Advanced Technical Information

Bulletin #: 1804

Panamera (971) Rear O2 Sensor Improvement

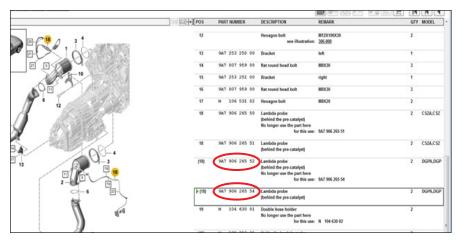
Customer complains of a check engine light. The fault codes P227000/P227200 are set.

The rear O2 sensor(s) is found to be bad. The sleeve on the O2 sensor was being heated enough that the fumes from it were contaminating the sensor.

Replace the rear O2 sensor(s) with a new sensor. The new parts are in PET: 9A7.906.265.51 and 9A7.906.265.54.

A new sleeve was introduced into vehicle production as of 5/15/2018.
